DETAILED ACTION

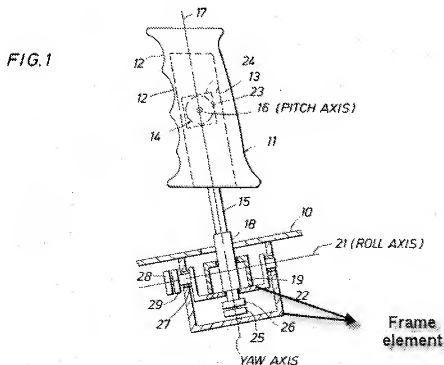
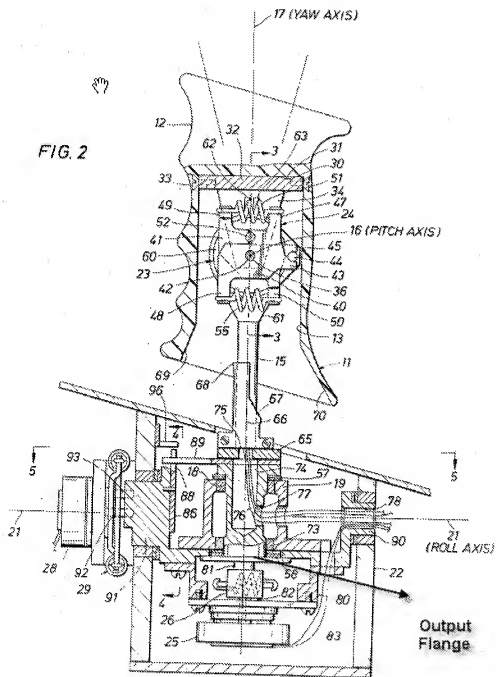
6. Claims 19- are rejected under 35 U.S.C. 102(b) as being anticipated by Bailey, Jr.. Bailey, Jr. discloses a similar device (see figure below).

- Bailey, Jr. teaches an apparatus (fig. 2) comprising a handle (fig.2, Item # 11) which is mounted upon two substantially perpendicular axes A (fig. 2, Item# 17) and B (fig. 2, Item# 21).

- Bailey, Jr. teaches an apparatus (fig. 2) comprising a handle (fig.2, Item # 11) which is mounted upon two substantially perpendicular axes (fig. 2, Items# 17 and 21). The applicant invokes 35 USC § 112th 6th paragraph in regard to a “holding means for holding a force sensor”. The examiner will apply the same analysis to holding means in future claims unless the language no longer fits 35 USC § 112th 6th paragraph. Therefore, Bailey, Jr. discloses a plate (fig.2, Item# 80) for holding a force sensor which is on axis A (fig. 2, Item# 17), and wherein the force sensor (fig.2, Item# 25) is arranged centrically, and offset vertically upwards with respect to axis A.

- Bailey, Jr. teaches a frame element (fig. 1, labeled by examiner) which is provided with two drive elements (fig.2, Items# 26 and 29) which act at substantially right angles to each other as depicted via figure 1 and 2.

- Bailey, Jr. teaches a first drive element (fig. 1, Item# 26) being connected to the baseplate and a second drive element fixed to the baseplate. The holding means is arranged within the baseplate as seen in figure 2 and can pivot about the axis A (col. 7, lines 40-46)(col.6, lines 37-39).

- Bailey, Jr. teaches the first drive element (fig.2, Item# 26) connected to the holding means via an output flange (fig. 2, labeled by examiner), on which

holding means and a handle are seated and wherein the handle is connected to the force sensor as shown in figure 2.

- Bailey, Jr. discloses a holding means being a plate as labeled in figure 2, which is pivotable about the axis A discussed above and is fitted with the force sensor.

FIG. 6

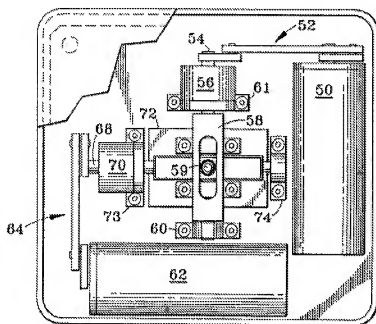
Marcus et al. teach a joystick device with an electronic control device (seen in the figure below and described in col. 1, lines 36+) comprising integrated force control and motor control via the electric motor (fig.6, Items# 50, 62) and a downstream

transmission(fig. 6, Items# 52). This electronic control device is used for the purpose of providing force feedback to the user. (col.2, lines 1-3)

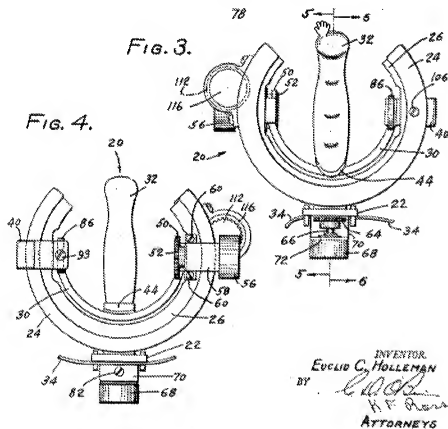
Bailey Jr. teaches a joystick device discussed above, comprising a second holding plate (fig.2, small right plate of housing Item# 22).

Holleman teaches a counterweight or balance weight (fig. 3, Item# 40) for the purpose of balancing the effect of inertial forces acting about the center of rotation of the joystick disclosed.
